CITY OF ALBUQUERQUE

RE: **Winrock Regal Cinema Temporary Parking
Amendment to Road B Extension
2100 Louisiana Blvd NE
Grading and Drainage Plan Stamp Date: 8/21/19
Hydrology File: J19D058H**

Based on submittal received on 8/22/19, the Grading and Drainage Plan cannot be approved until the following are corrected:

GRADING PLAN

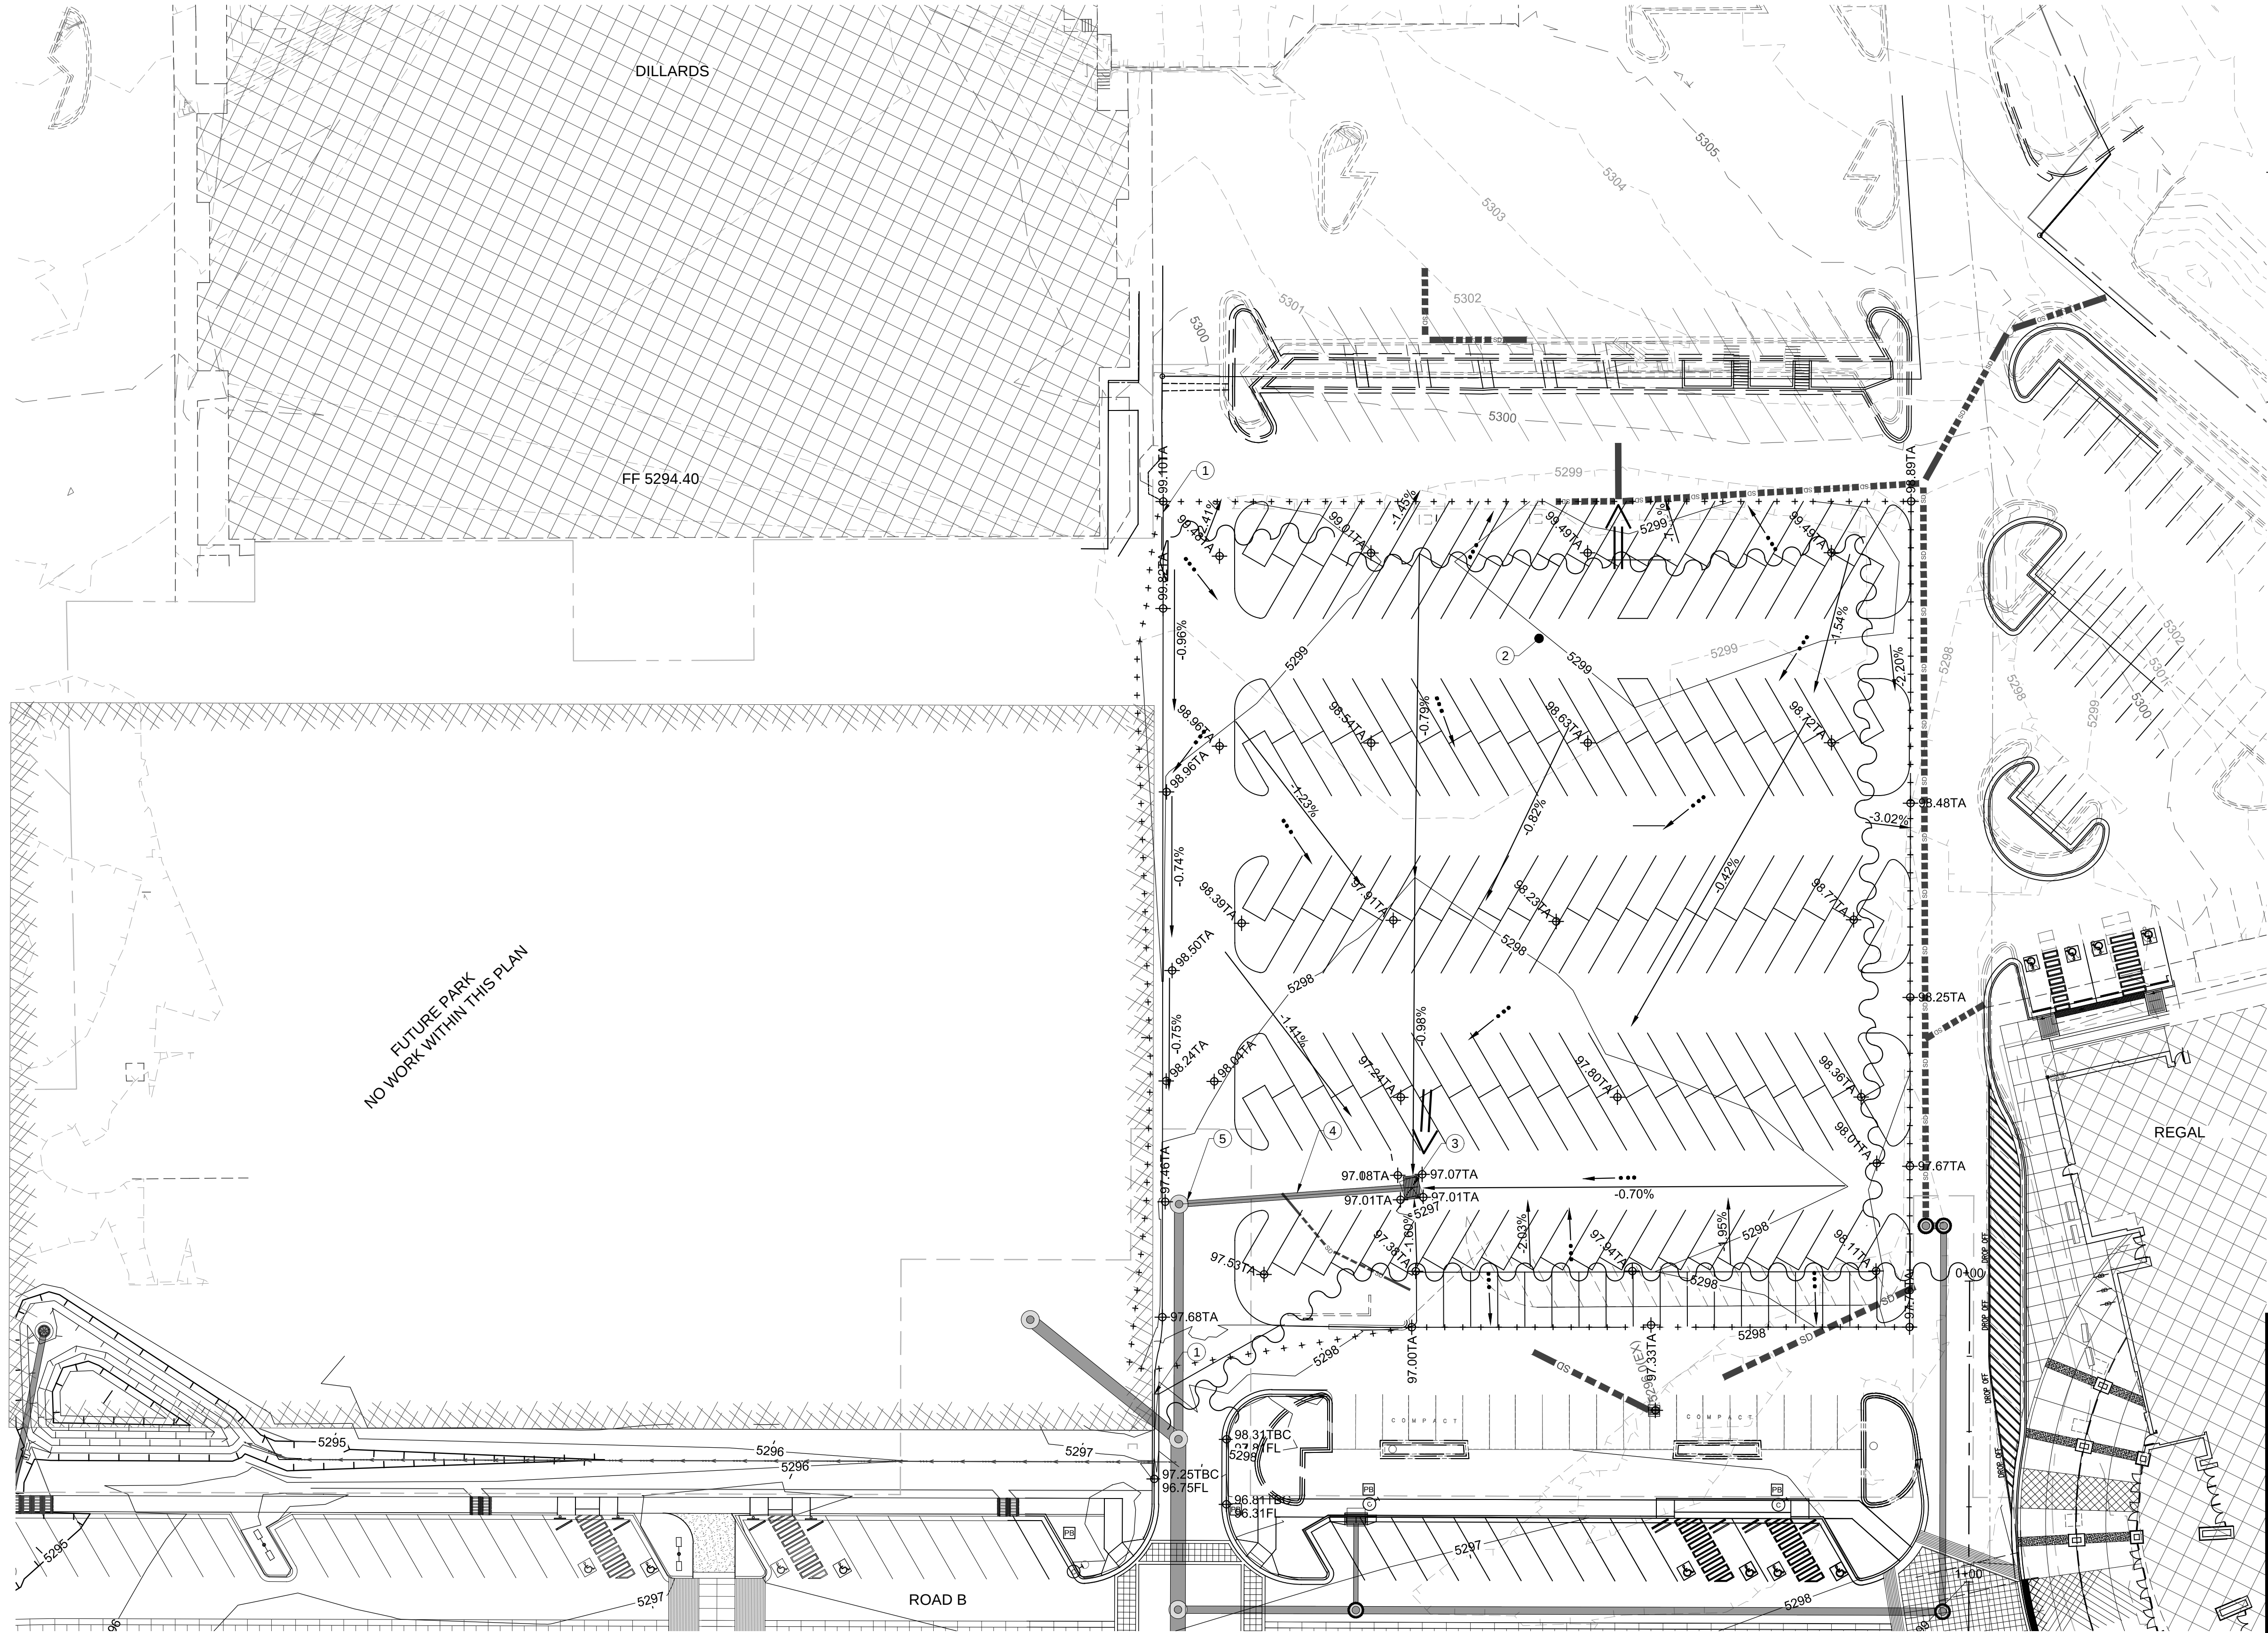
1. Show all proposed (temporary) grading in the future park area; the site is being graded now and we need a plan for it (§ 14-5-2-12-B-4).
 - a. Provide temporary ponding for the 100-yr volume.
 - b. Special care needs to be taken with respect to grading around the adjacent buildings to prevent water from entering them. Notably, Dillard's has a finished floor of 5294.4', but surrounding grades are ~5298'.
 - c. Add callouts as necessary that grading is temporary and will be revised when the park is constructed.
2. Construction notes 3 and 4 need to be swapped.
3. For Information. The ponds being proposed will need to be surveyed, certified, and inspected as part of the Work Order close-out.
